Land North West of Bicester

Third Environmental Statement Addendum

Third Environmental Statement Addendum

Project Ref:	31036/A5/Reports/ESAddendum	
Status:	Draft	Final
Issue/Rev:	01	02
Date:	March 2022	
Prepared by:	MM	
Checked by:	LW

Drawing Title
Development Parameter Plan 3 :
Access and Movement

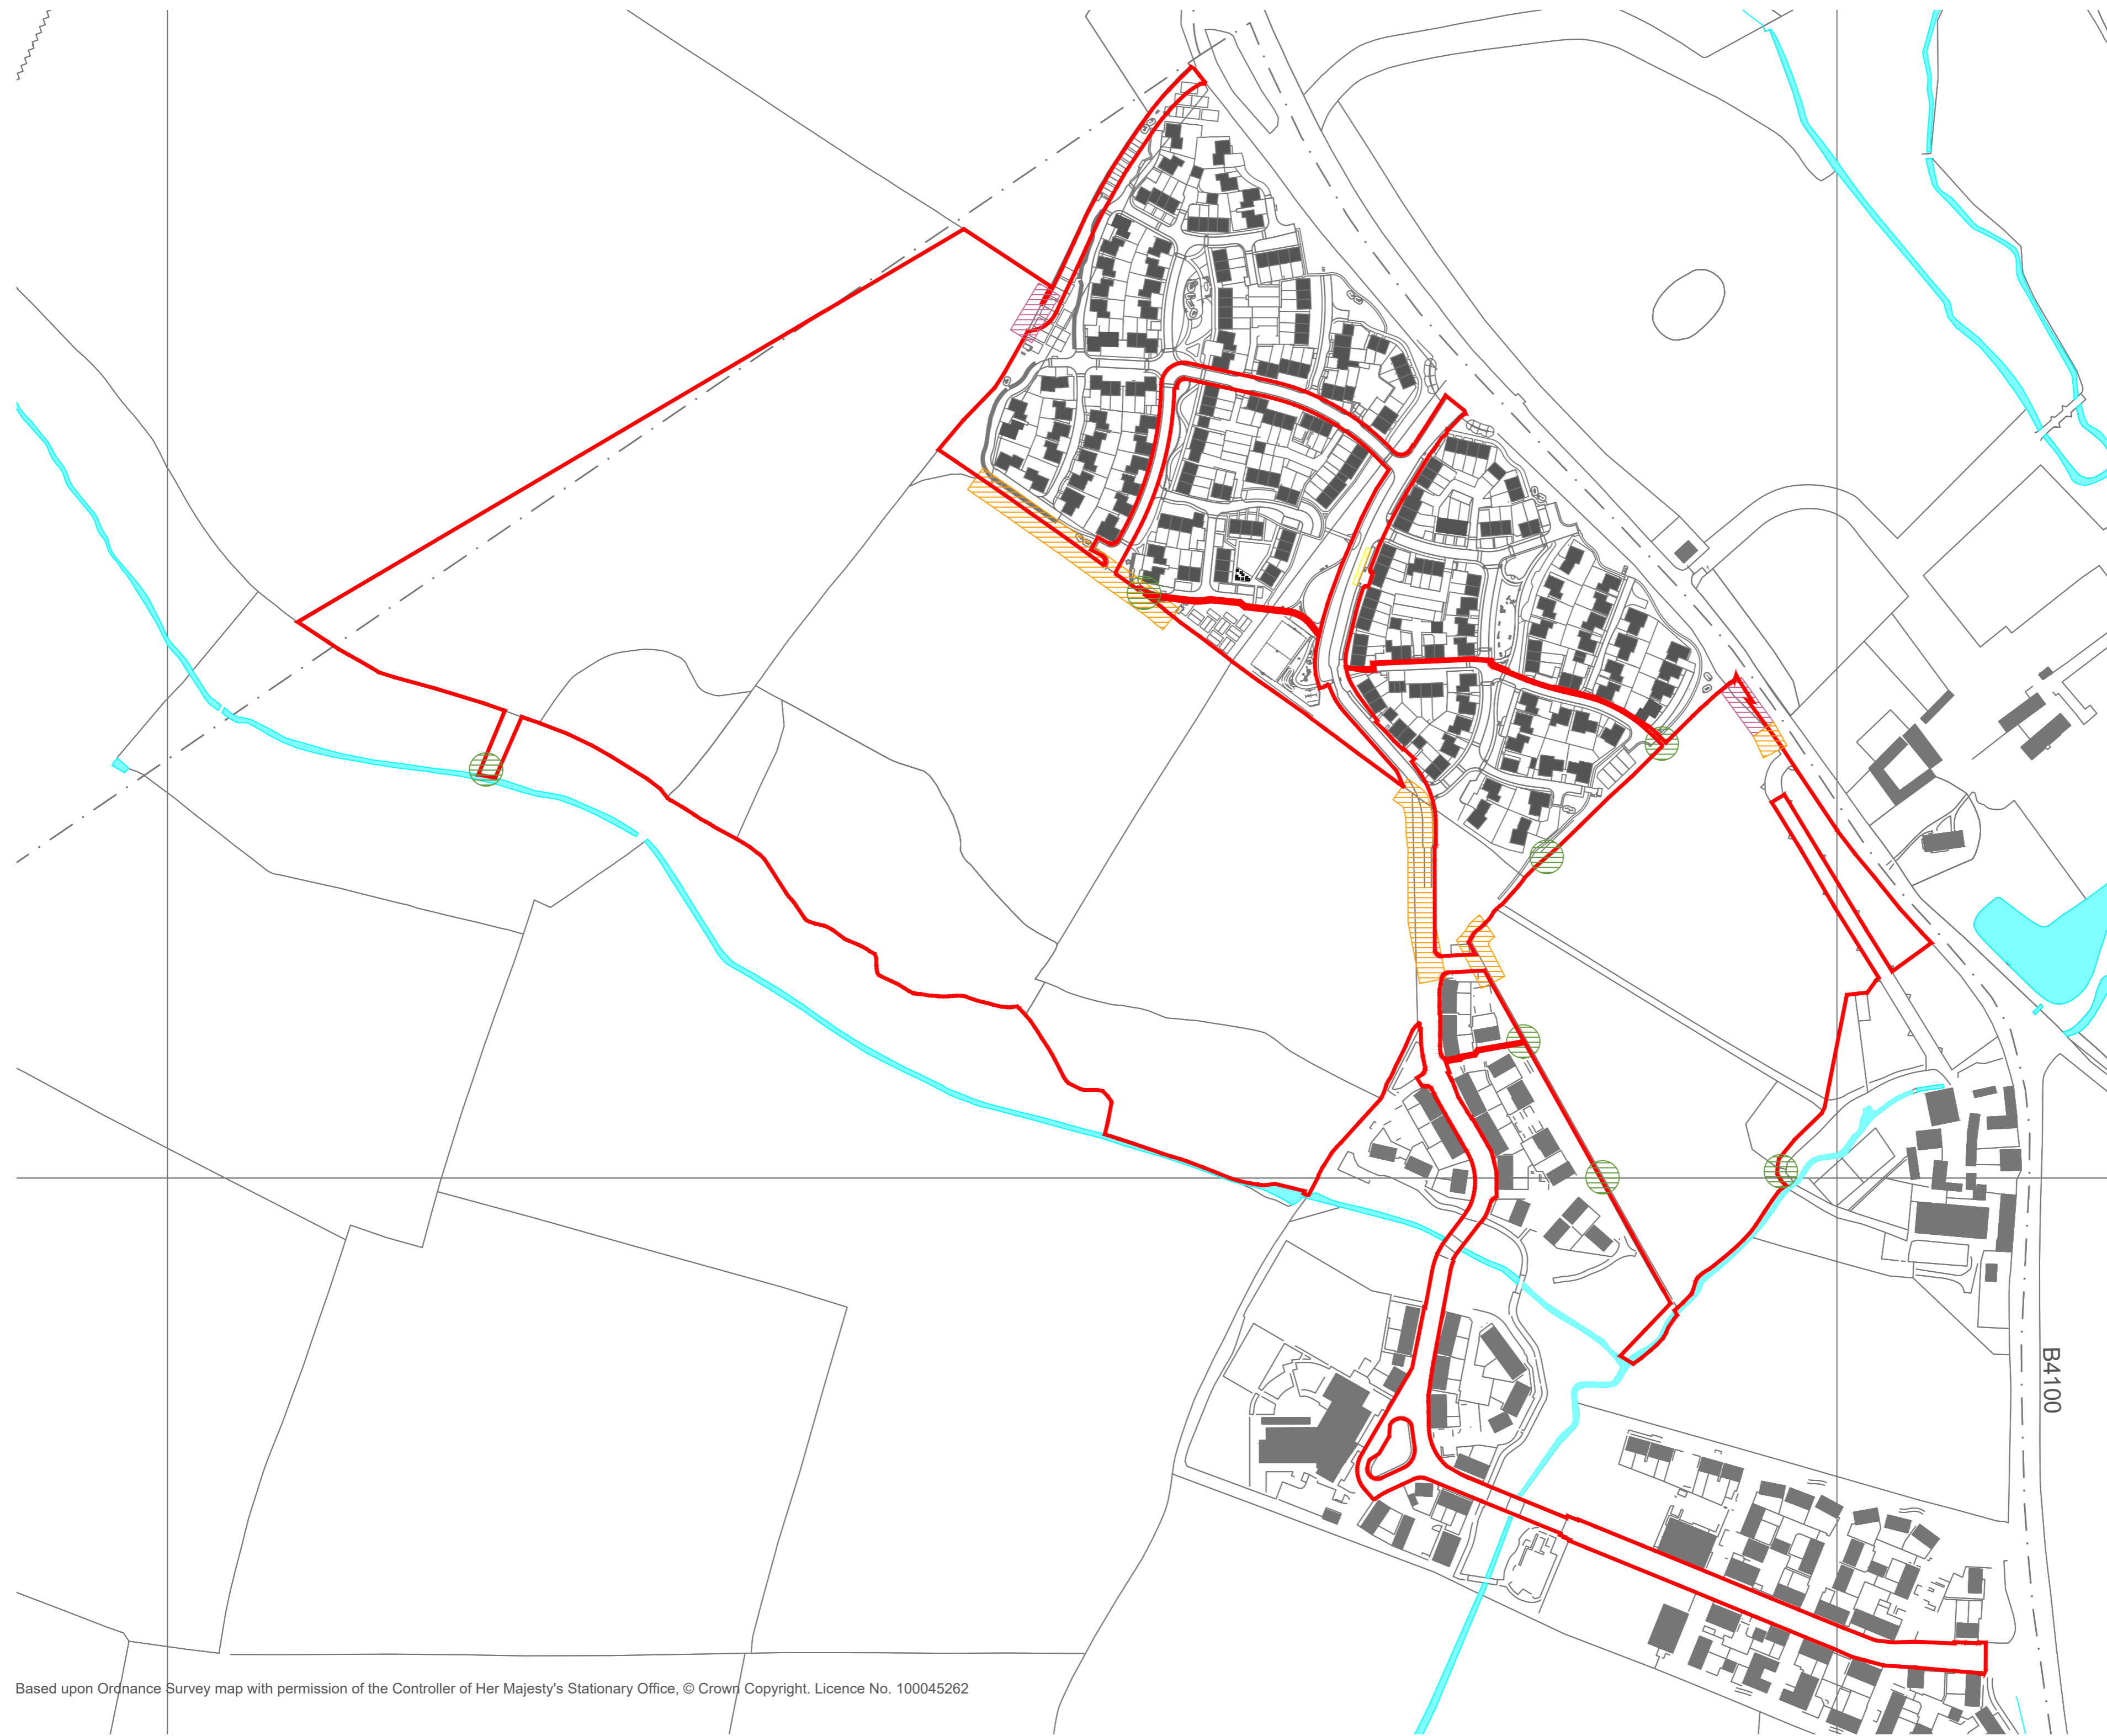
- **Update of the parameter plan Figure 3.3 to reflect the revised potential pedestrian cycle access provision.**

highway connection points, as shown on Figure 3.3~~A~~**B**. Pedestrian and cycle connections will be provided at each of the vehicular access points. Safe and attractive environments for walking and cycling will be provided to encourage local journeys to be made sustainably.

Figure 1 – Comparison of the 0.1% Event with 25% Topsoil and Surface Water Flood Extent

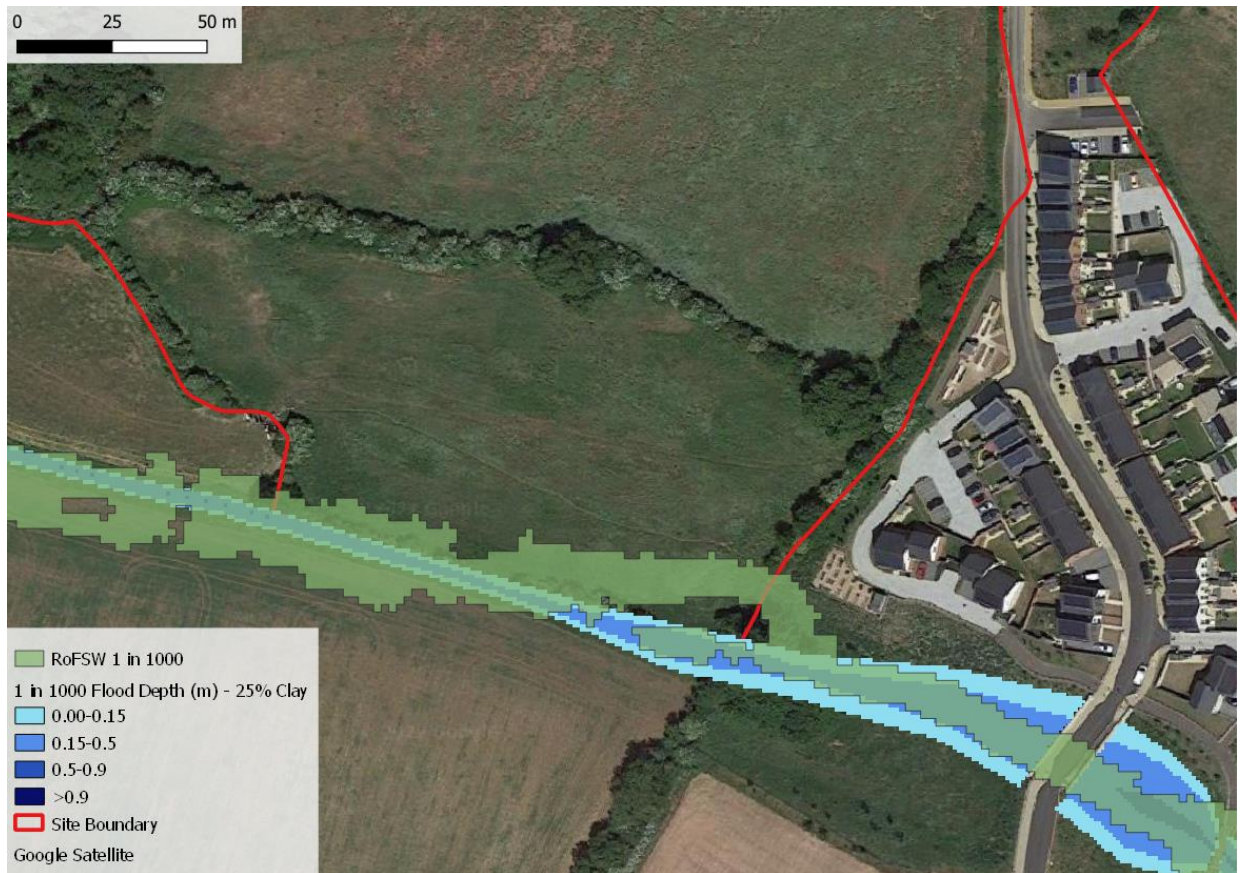
The very conservative sensitivity test outlined above has not changed this conclusion. The resultant flood extent associated with a theoretical 25% clay topsoil coverage is still smaller than that defined by the two data sources identified above. This is shown in Figure 1 and 2.

Whilst it is accepted that the findings of the ground investigation for the site has introduced a little uncertainty with respect to the hydrological calculations, this has no bearing on the conclusions or purpose of this study. There is no desire to update the Flood Map for Planning and it has been shown that the masterplan is robust and any potential uncertainty will not introduce developed parts of the site into the floodplain.
